Log # TXX-91198
File # 915
10010

SUBJECT: COMANCHE PEAK STEAM ELECTRIC STATION (CPSES)
DOCKET NOS. 50-445 AND 50-446
RESPONSE TO REQUEST FOR ADDITIONAL INFORMATION
REGARDING TOPICAL REPORT RXE-89-003,
"STEADY STATE REACTOR PHYSICS METHODOLOGY"

ADDITIONAL INFORMATION REGARDING
TOPICAL REPORT RXE-89-003,
"STEADY STATE REACTOR PHYSICS METHODOLOGY"

FIGURE 3. COMANCHE PEAK STEAM ELECTRIC STATION UNIT 1,
CYCLE 1, BORON LETDOWN

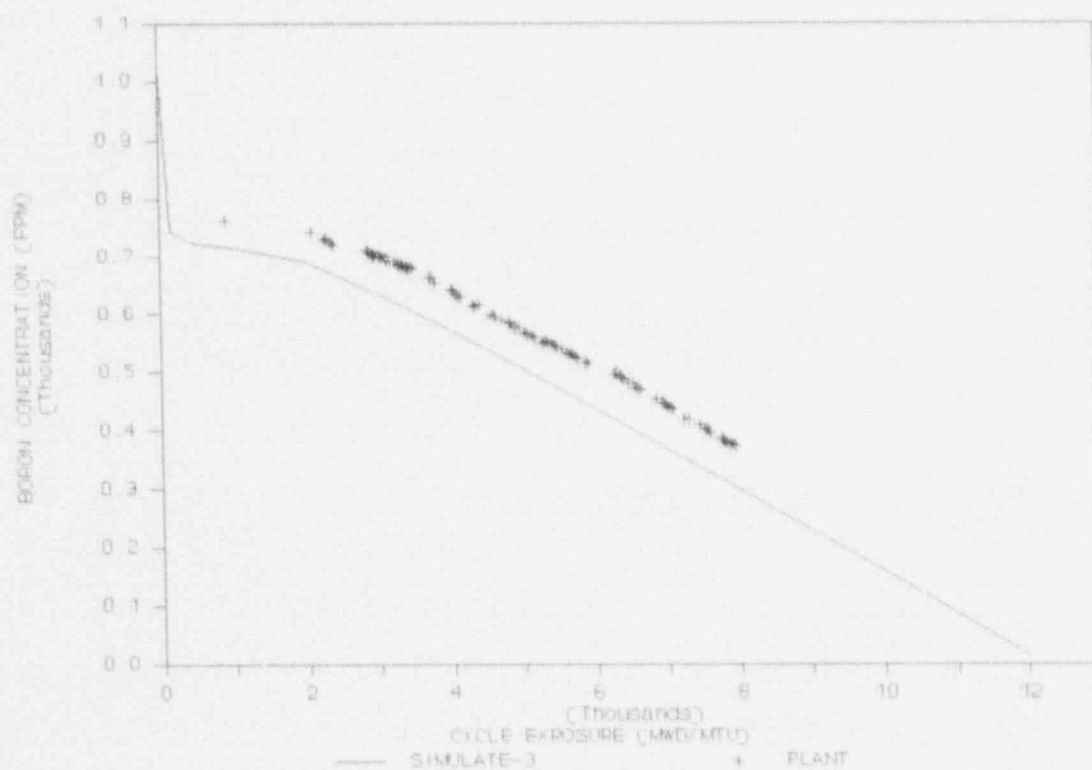
Both PDQ-7 and SIMULATE-3 analyses of the Catawba-1 boron letdown curves show an underprediction of the boron concentration throughout most of Cycle 1. SIMULATE-3 also underpredicts the letdown curves for Prairie Island Cycles 5-10. Is this underprediction expected in the Comanche Peak-1 calculations? What is the measured vs. calculation experience thus far in Cycle 1?

Based on the above, an underprediction was expected for CPSES Unit 1, Cycle 1. The calculated and measured boron letdown curve for CPSES Unit 1, Cycle 1 is presented in Figure 3.
